VALUE ENGINEERING STUDY

Project # CSSTP-0006-00(252) PI No. 0006252
Project # CSSTP-0006-00(253) PI No. 0006253

**S.R. 44 from US 441 to I-20
Putnam/Greene County, Georgia**

6 December 2012

R2-12 Original Design
8 of 17

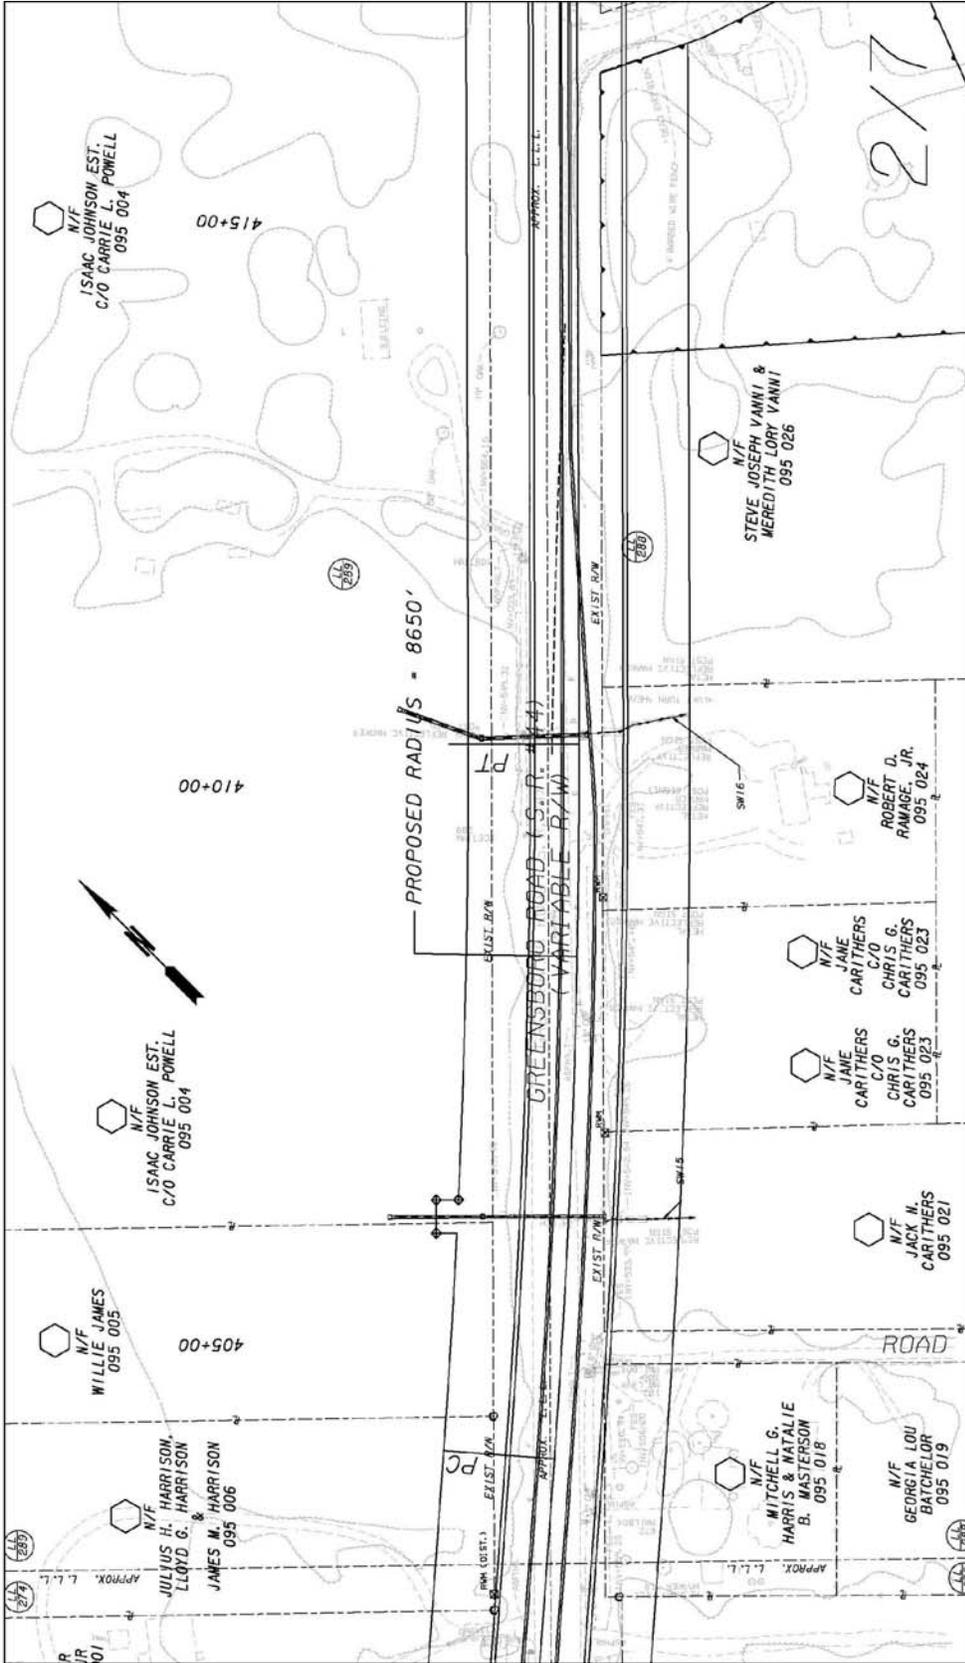
PROPOSED CHANGE: It is proposed to shift the horizontal alignment of SR44 to more closely follow the existing alignment and avoid the displacements on the West side of the road.

JUSTIFICATION: With the removal of the eligibility of the historic resource on the West side of SR 44 at Sta. 414+00 the alignment of SR44 can be revised to closer match the existing and will meet the required 55 mph design speed in the rural section and will meet the requirements of GDOT and AASHTO.

R2-16 Proposed Change
 4 of 6

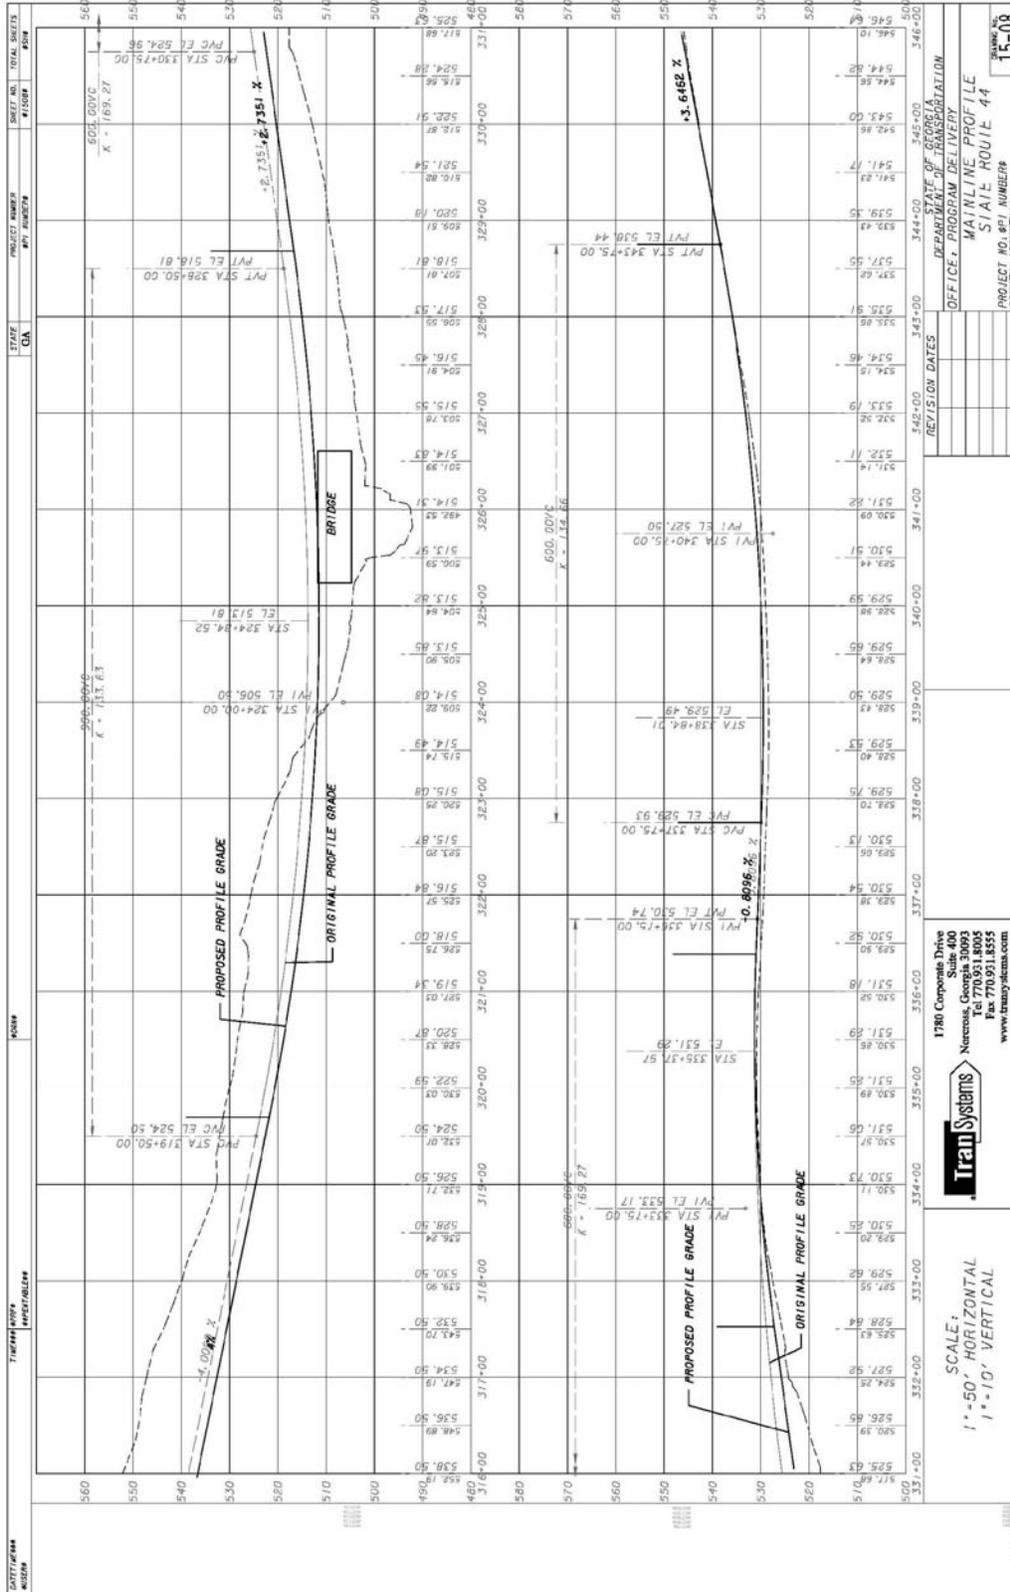
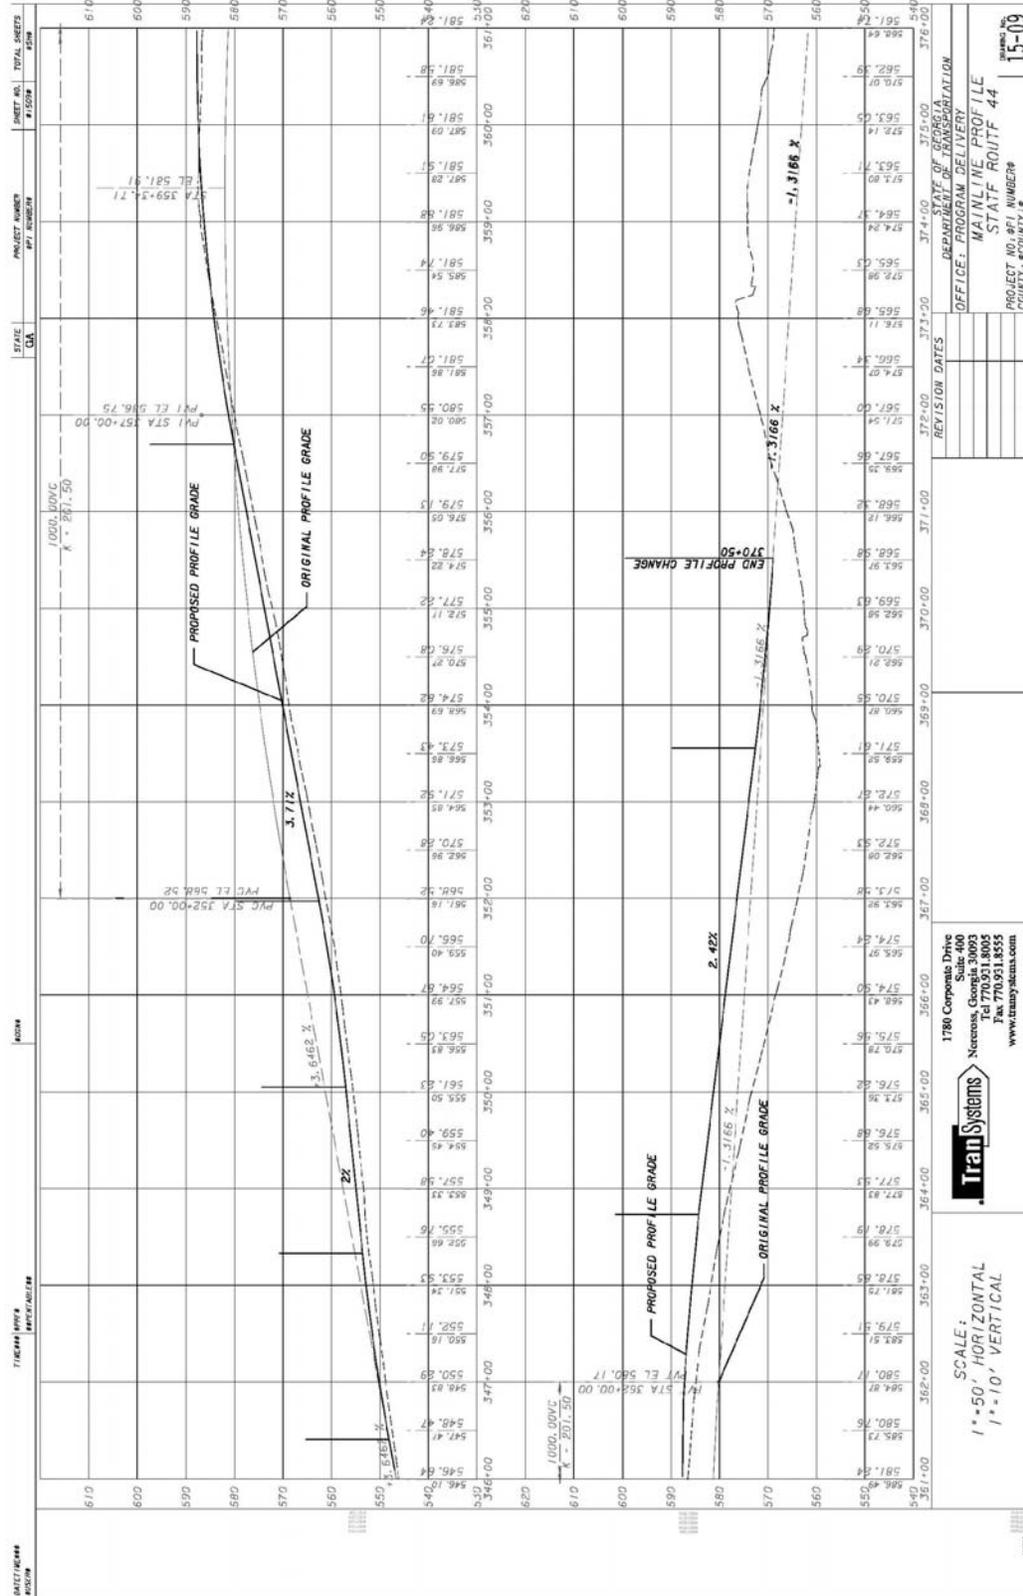
PROPOSED CHANGE: It is proposed to develop a vertical profile that more closely follows the existing terrain or roadway and still meets the desired speed design of 55 mph. The bridge over Crooked Creek will also be lowered to reduce the length and therefore will reduce the cost. (See B2-2 for additional bridge information).

JUSTIFICATION: The vertical alignment can be revised to reduce earthwork and still maintain the required design speed of 55 mph and meet the requirements of GDOT and AASHTO.

PROPOSAL NUMBER: B3-4

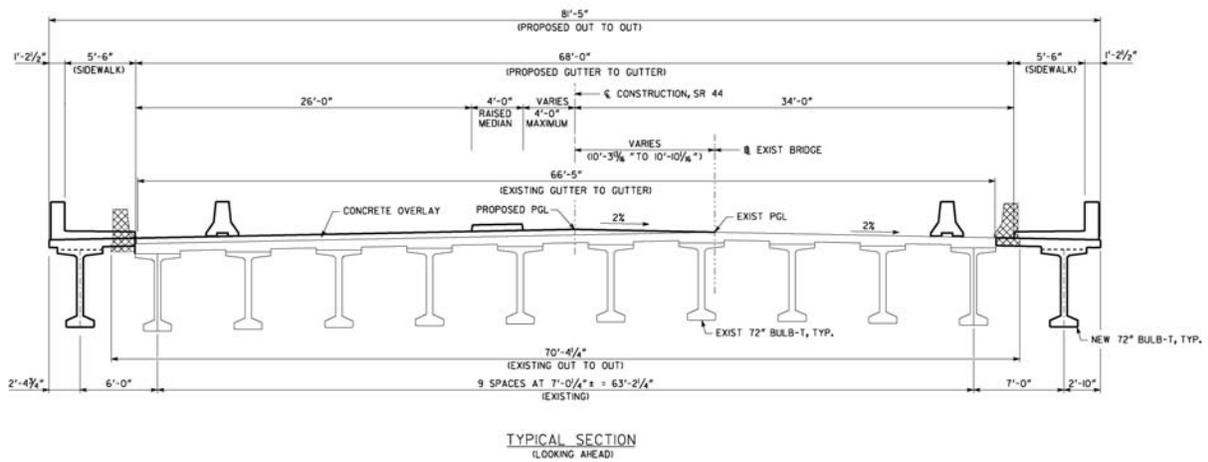
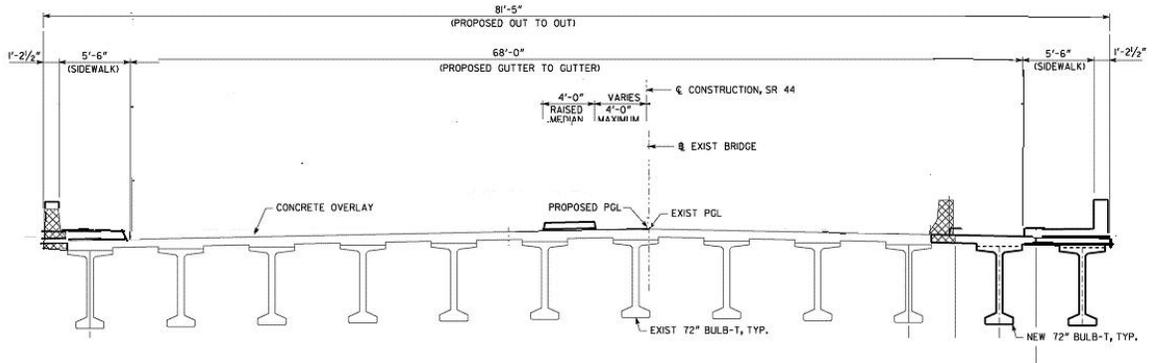
PROPOSED CHANGE: It is proposed to widen the bridge on 1 side only and keep the PGL on the existing PGL.

PROPOSAL NUMBER: B3-4.1

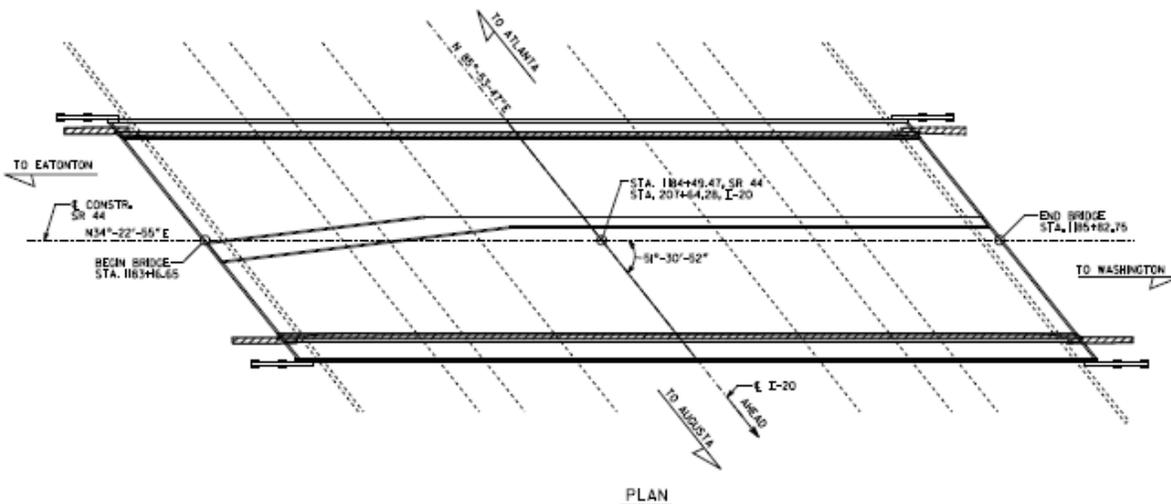
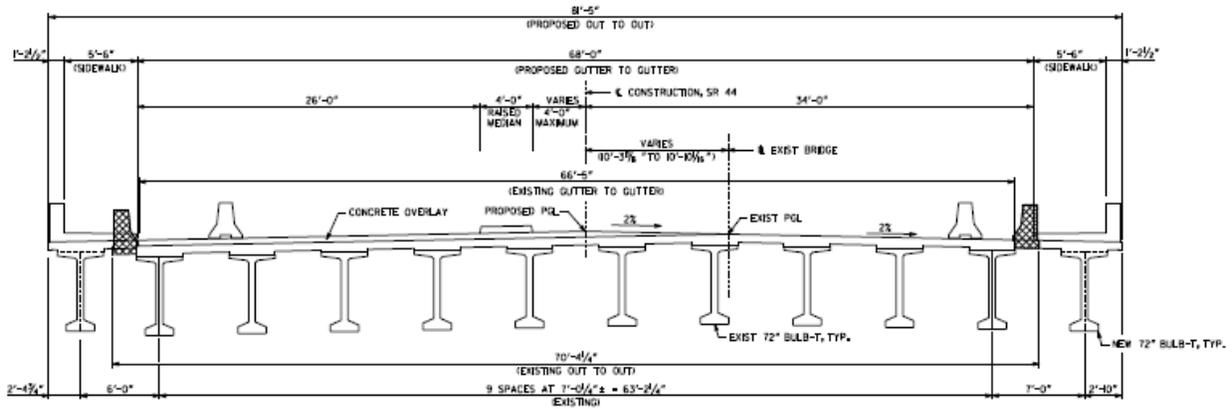
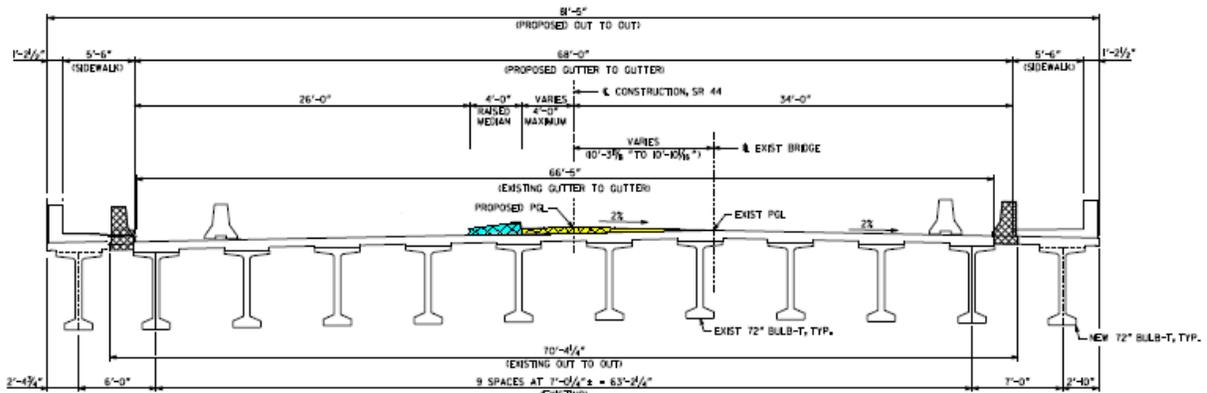
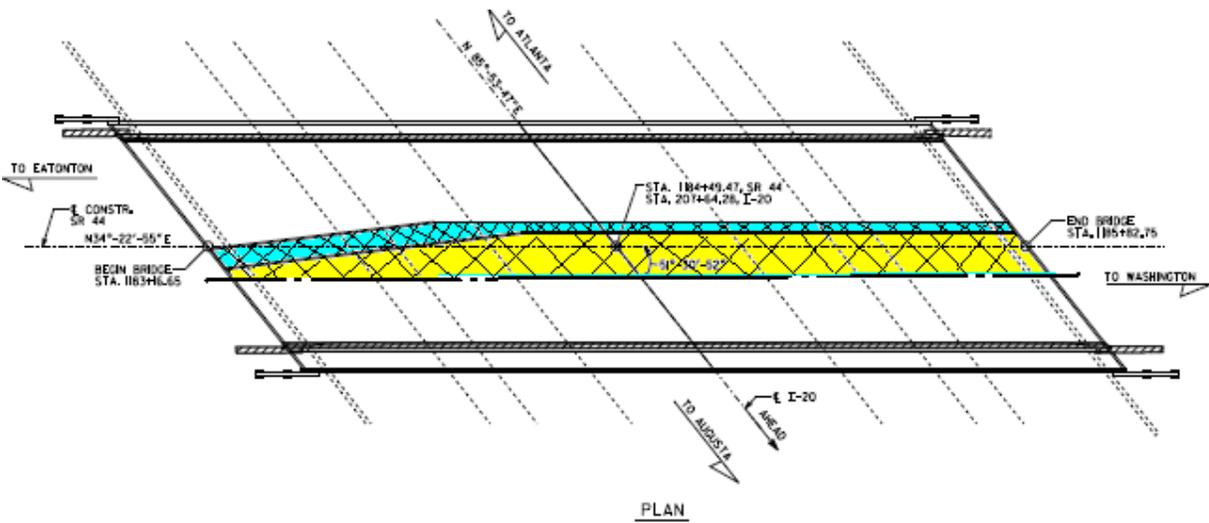
PROPOSED CHANGE: It is proposed to maintain the original design plan layout and PGL location. However, reduce the extent of overlay to the portions of deck to the right of the raised median.

PROPOSAL NUMBER: R3-1

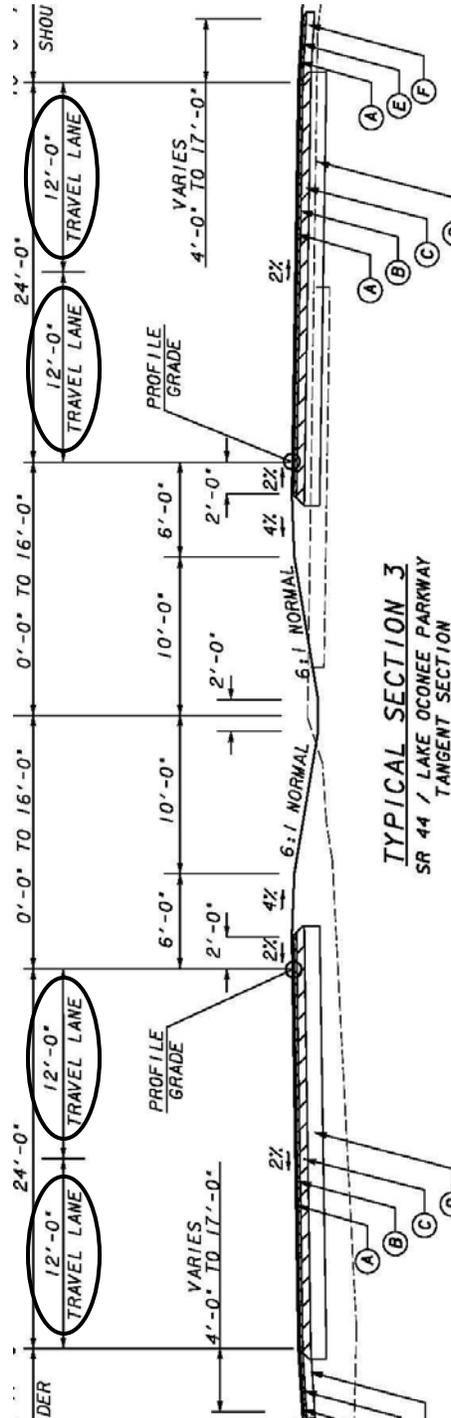
PROPOSED CHANGE: It is proposed to reduce all travel lanes on the rural sections from 12' to 11'.

Proposed Change: Revise 12'0" travel lanes to 11'0"

PROPOSAL NUMBER: R3-1.1

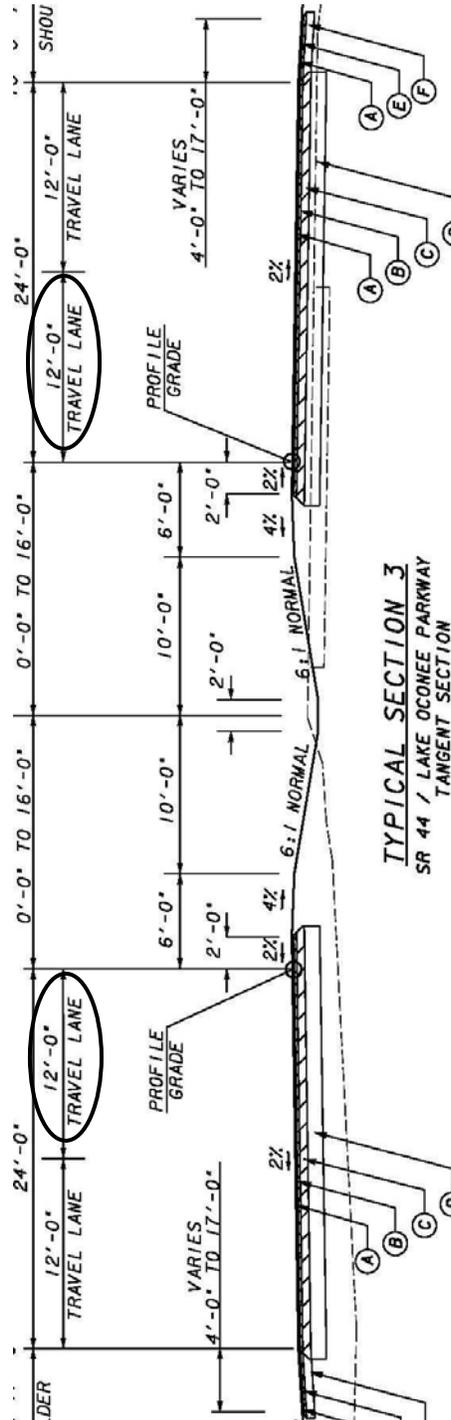
PROPOSED CHANGE: As an alternative to proposal R3-1, it is proposed to reduce the inside travel lanes on the rural sections from 12' to 11' while maintaining the 12' width on the outside lanes.

Proposed Change: Reduce inside travel lanes from 12'0" to 11'0"

PROPOSAL NUMBER: R3-2

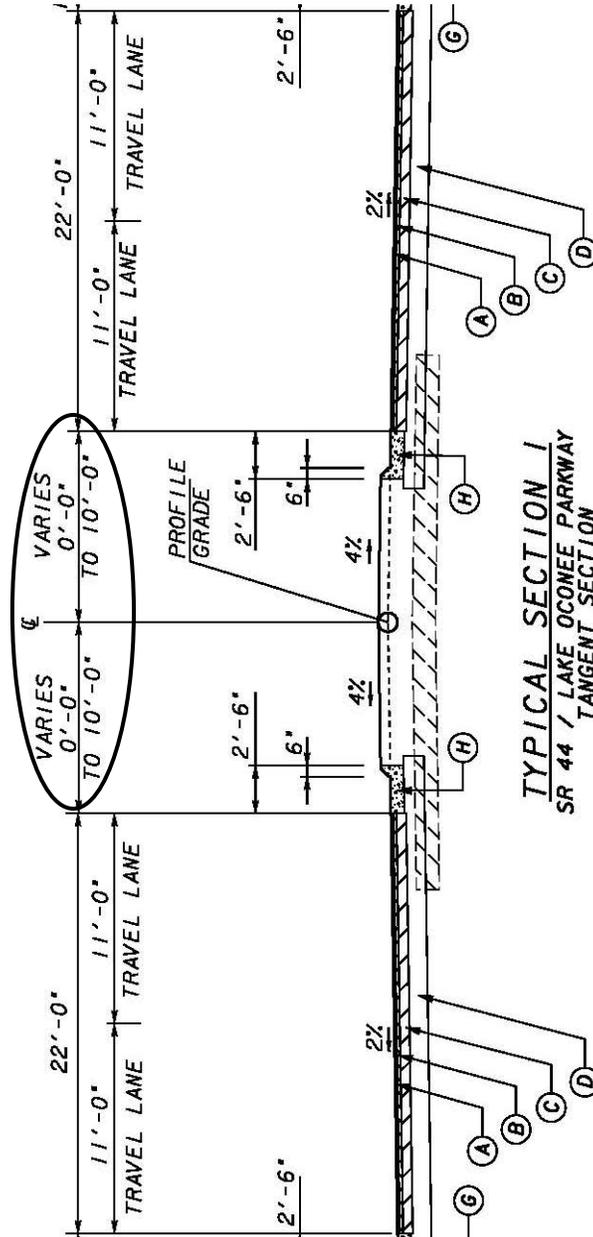
PROPOSED CHANGE: It is proposed to change the width of the raised median from 20 feet to 16 feet for typical section #1 and #2.

Proposed Change: Reduce 20'0" median to 16'0"

PROPOSAL NUMBER: R3-4

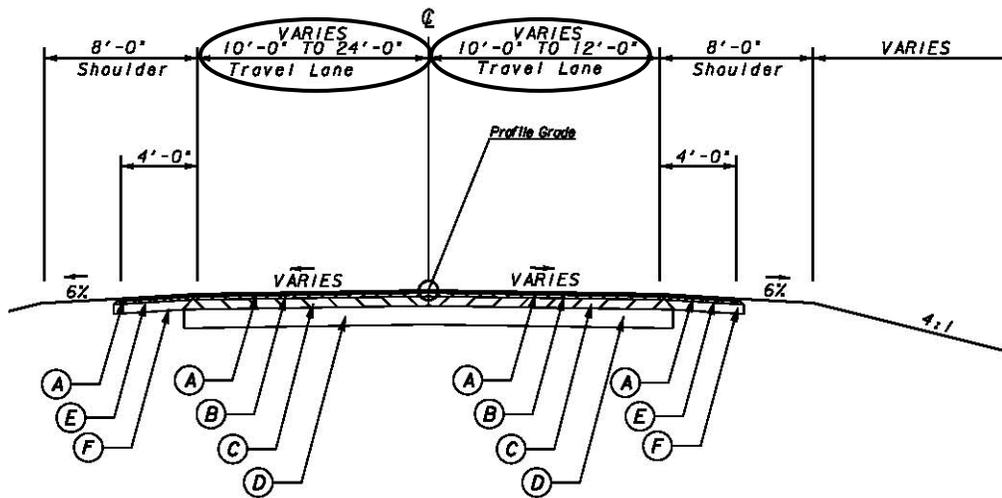
PROPOSED CHANGE: It is proposed to reduce all travel lanes on the side street sections from 12' maximum to 11' maximum.

JUSTIFICATION: Based on the current plans, the existing side streets appear to be less than 12' in lane width and GDOT design policy allows 11' lanes for local roads as indicated in Table 6.4 of the Design Policy Manual.

Proposed Change: Revise 12'0" travel lanes to 11'0" max.
